Our ref: Q10064
Your ref: 22/03045/VAR
Email: sean.bashforth@quod.com
Date: 25 April 2023

**TOWN AND COUNTRY PLANNING ACT 1990 (AS AMENDED)
SECTION 73 APPLICATION to VARY VARIOUS CONDITIONS ATTACHED
TO PLANNING PERMISSION 13/01228/FUL (LPA REF. 22/03045/VAR): GLA
STAGE 1 REPORT**

I refer to the above S73 application and write to respond to matters raised in the Mayor of London's 'Stage 1 Report' (Ref GLA/2023/0094/S1/01) dated 20 March 2023.

Figure 1: Predicted annual mean nitrogen dioxide concentrations in 2031 for the DM and DC scenarios at modelled receptors.

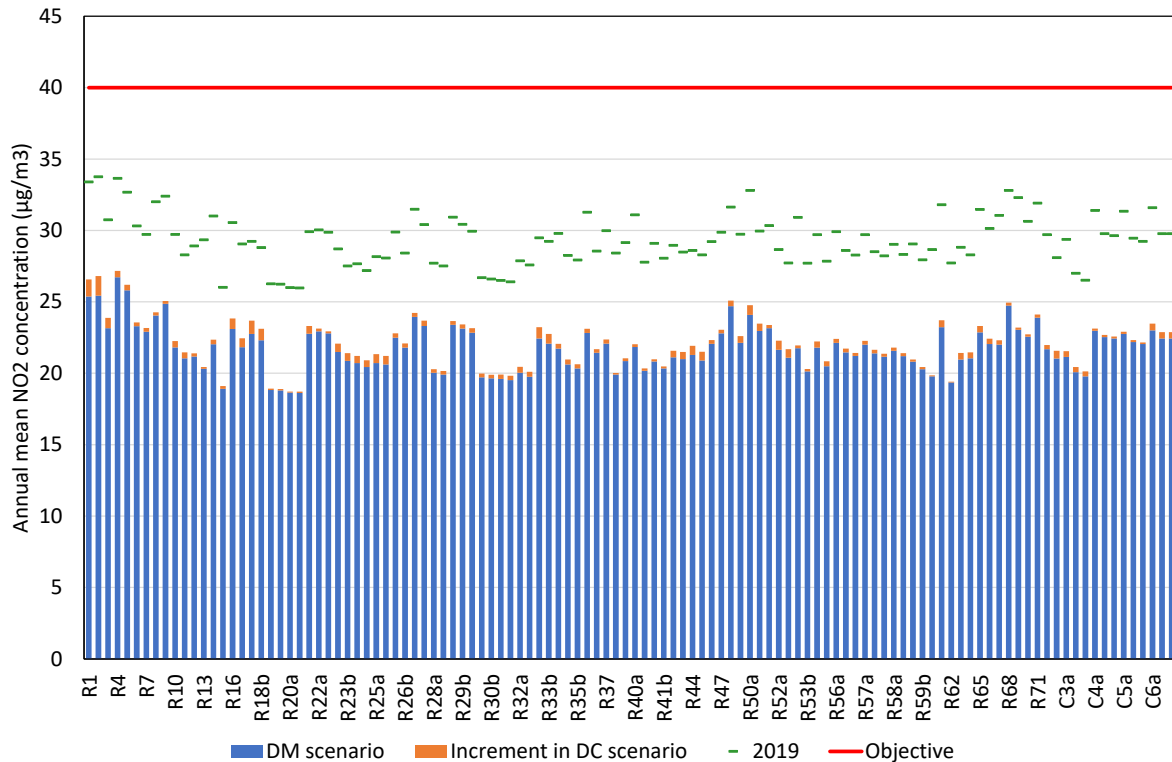
GLA comment (para 66, bullet 2):

objectives / limit values brought about by other national, regional or local policies, as illustrated in Figure 1 below. The analysis has been carried out for 2031 which represents the greatest changes to road traffic flows and aircraft movements. Figure 1 also shows concentrations in 2019 (green lines), showing that concentrations in 2031 will be well below the current levels.

The incremental change due to the proposed development is small at some receptors, and indistinguishable at most, and concentrations are substantially below the objective / limit value.
